EXCAVATION AND FLOOD PROTECTION - 17TH STREET CANAL CAPPING OF FLOODWALLS EAST SIDE LEVEE IMPROVEMENTS

AMENDMENT OF SOLICITATION/MODIFICATION OF CONTRACT 1. CONTRACT ID CODE PAGE OF PAGES
1 8

2. AMENDMENT/MODIFICATION NO. 0002	3. EFFECTIVE DATE 05/28/93	4. REQUISITION/PURCHASE REQ. NO. ED0000-3336-0063	5. PROJECT NO. (If applicable) dkn
6. ISSUED BY US ARMY ENGR DIST NEW ORLEANS PO BOX 60267 NEW ORLEANS LA 70160-0267 Molly M. Block		7. ADMINISTERED BY (If other than Item 6) US ARMY ENGR DIST, NEW ORLEANS ATTN CELMN-CT PO BOX 60267 NEW ORLEANS LA 70160-0267	
CODE ISSUE1		CODE ADMIN1	
SC2 (504)862-2879

PLANS AND SPECIFICATIONS FOR LAKE PONTCHARTRAIN LA & VICINITY, HURRICANE PROTECTION PROJECT, HIGH LEVEL PLAN, 17TH ST. OUTFALL CANAL, FLOOD PROTECTION IMPROVEMENT PROJECT, CAPPING OF FLOODWALLS, EAST SIDE IMPROVEMENTS, ORLEANS PARISH, LA, ARE HEREBY AMENDED AS FOLLOWS:

PLAN
SCALE 1" = 100'-0"

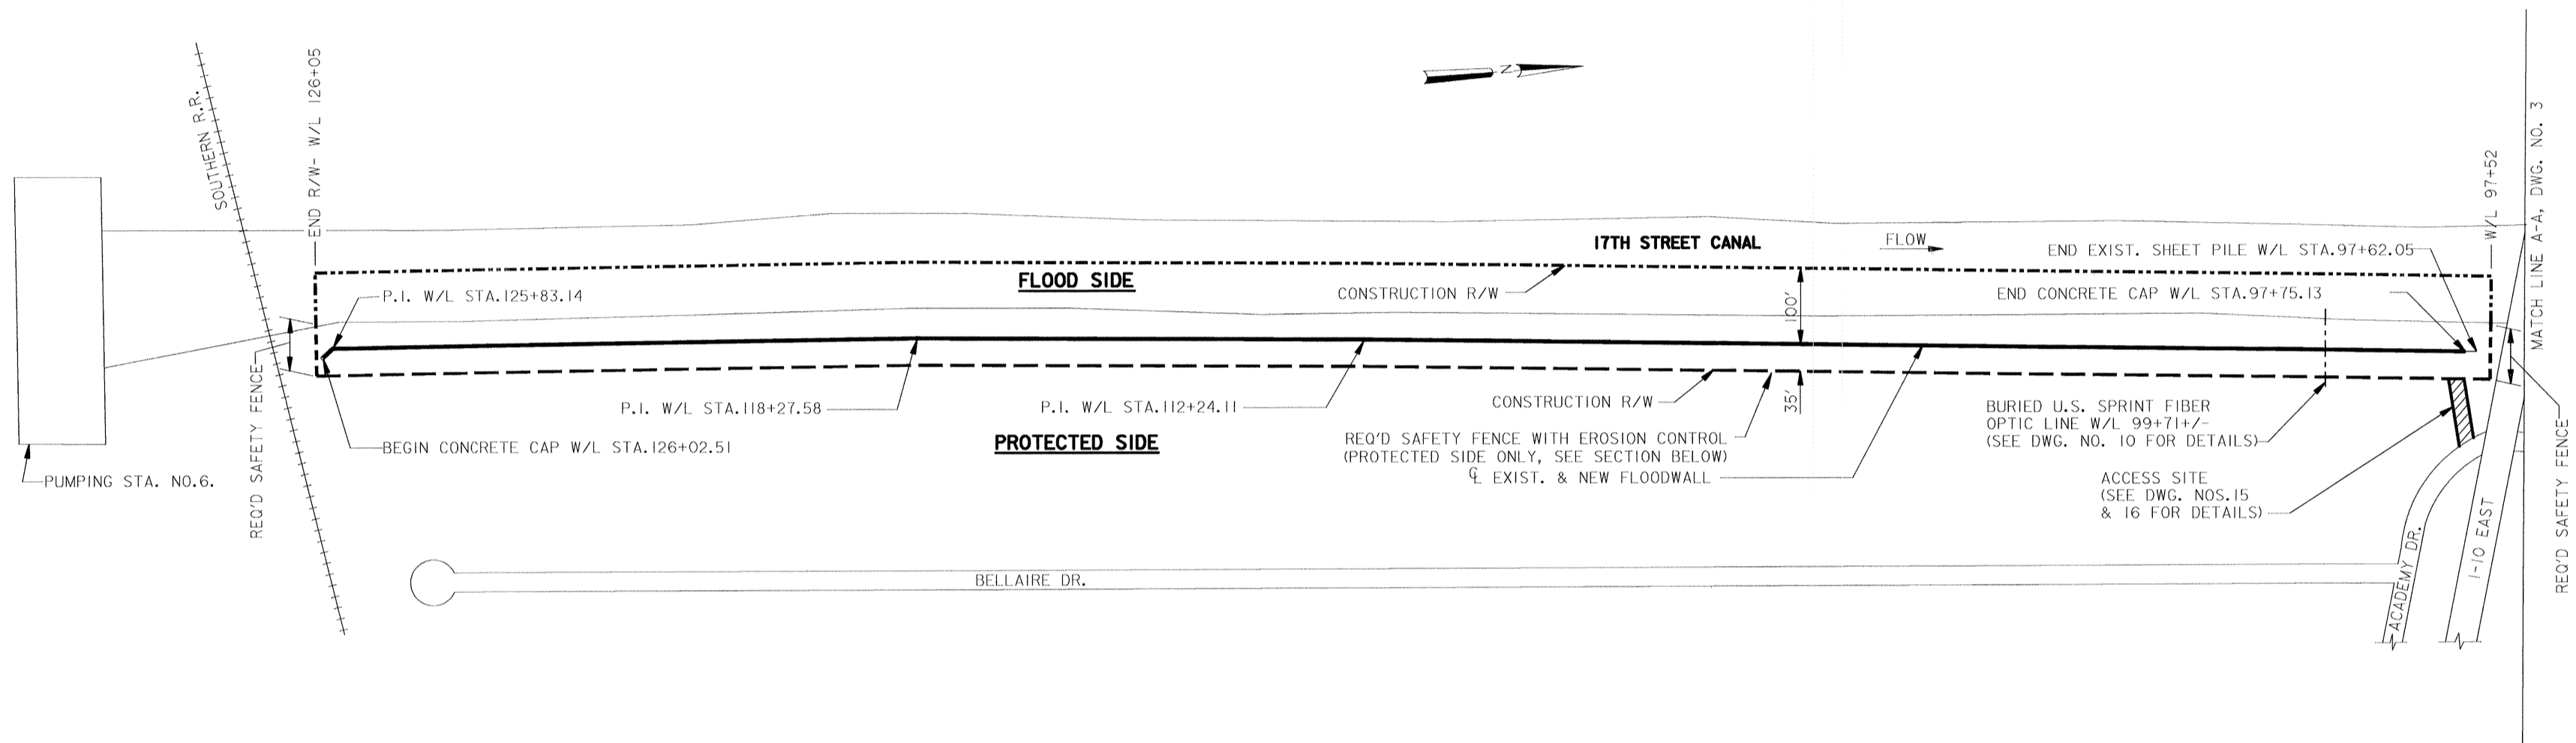
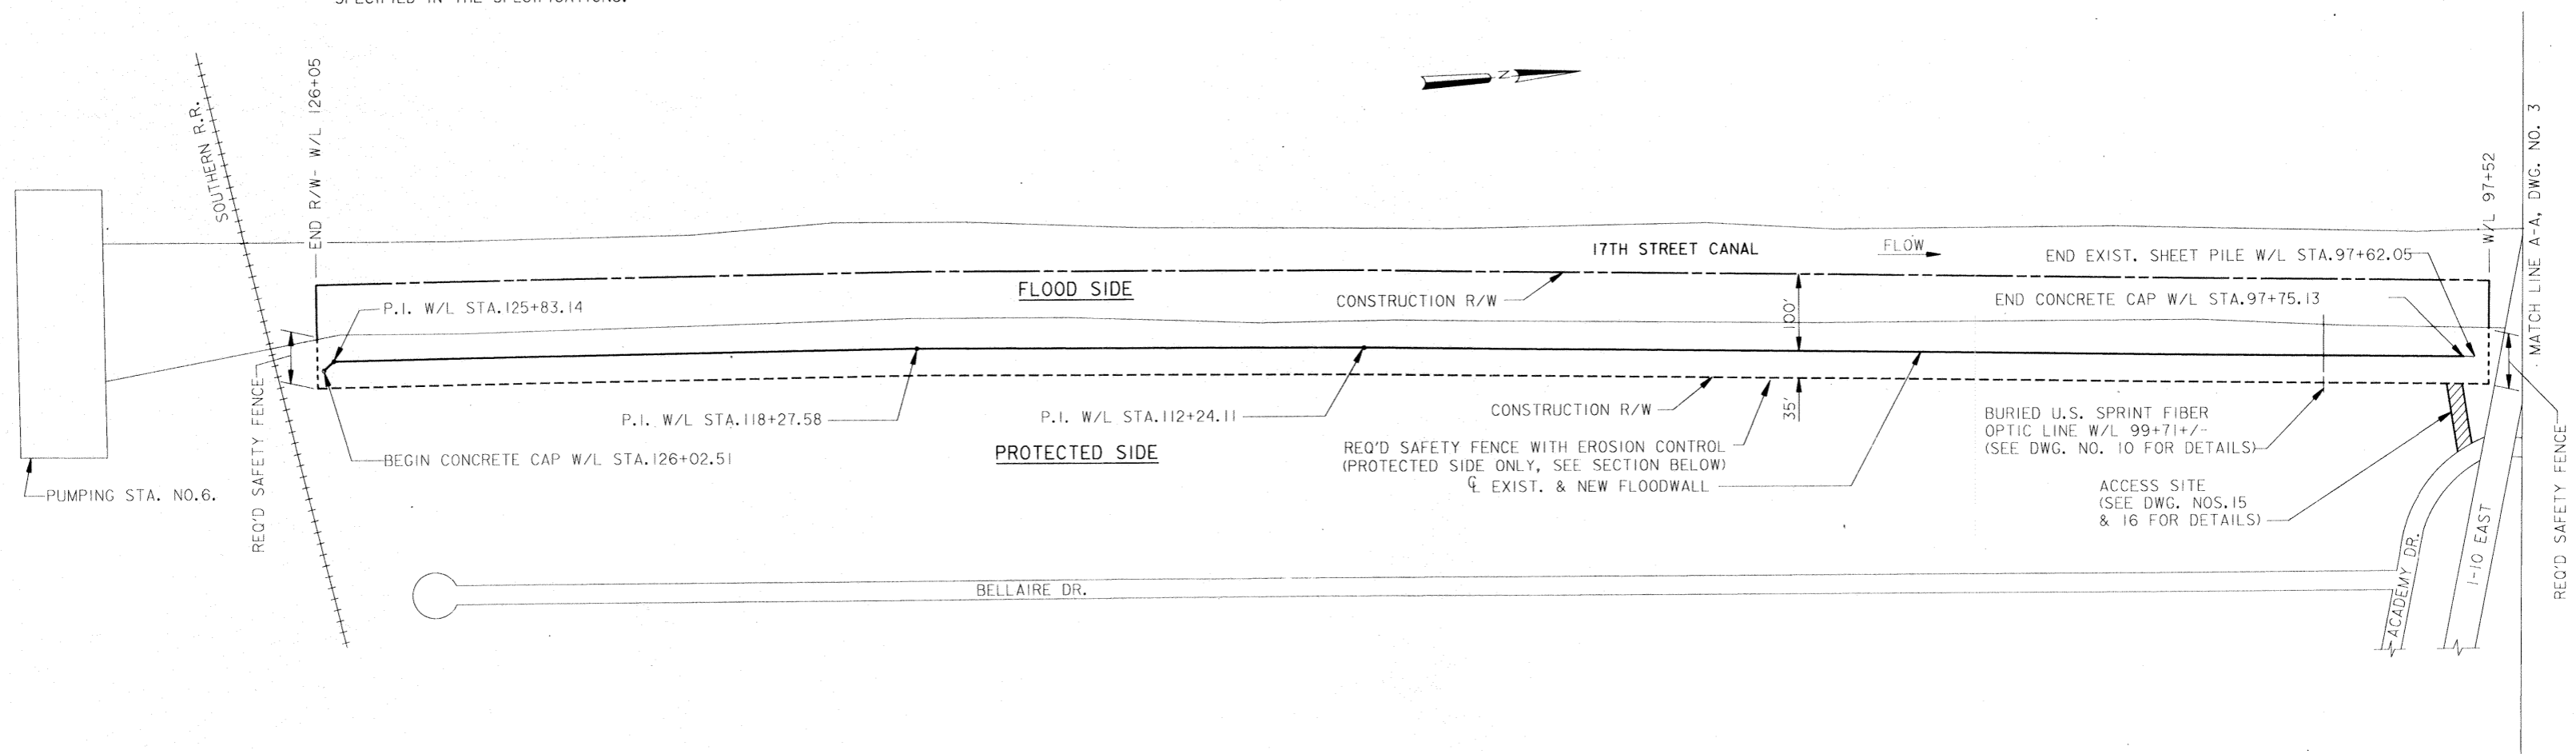
△	CHANGED NOTE 5 FROM REMOVAL OF COAL TAR EPOXY TO STUD ANCHORS AMEND. #2	21 MAY 1993	R/JG
SYMBOL	DESCRIPTION	DATE	APPROVED
REVISIONS			
U.S. ARMY ENGINEER DISTRICT, NEW ORLEANS CORPS OF ENGINEERS NEW ORLEANS, LOUISIANA			
BOARD OF LEVEE COMMISSIONERS ORLEANS LEVEE DISTRICT NEW ORLEANS, LOUISIANA		MODJESKI & MASTERS Inc. NEW ORLEANS, LOUISIANA	
LAKE PONTCHARTRAIN, LA. AND VICINITY HIGH LEVEL PLAN 17TH STREET CANAL EXCAVATION AND FLOODWALL PROTECTION CAPPING OF FLOODWALLS EAST SIDE LEVEE IMPROVEMENTS			
PLAN-1 AND GENERAL NOTES			
DESIGNED BY: F.S.	DATE: NOV. 1992	PLOT SCALE: 1200	PLOT DATE: APR 1993
DRAWN BY: P.M.R.	CHECKED BY: M.L.S.	CADD FILE: 40208X02.DGN	FILE NO. H-4-40208
SUBMITTED BY: W. D. CONWAY MODJESKI & MASTERS Inc. DESIGN ENGINEER		SOLICITATION NO. DACW29-93-B-0025	DWG. 2 OF 16

5. THE CONTRACTOR SHALL WELD 5/8 IN. BY 8 IN. STUD ANCHORS ON THE EXISTING SHEET PILE AS INDICATED AND SPECIFIED IN THE SPECIFICATIONS.
6. THE CONTRACTOR SHALL NOTE THE CLOSE PROXIMITY OF RESIDENCES, TREES, AND UTILITIES ALONG THE ENTIRE LENGTH OF THE PROJECT SITE. HE SHALL EXERCISE EXTREME CAUTION AT ALL TIMES WHEN WORKING ON THE LEVEE AND HE SHALL BE RESPONSIBLE FOR THE REPAIR OF ANY DAMAGE RESULTING FROM HIS OPERATIONS.
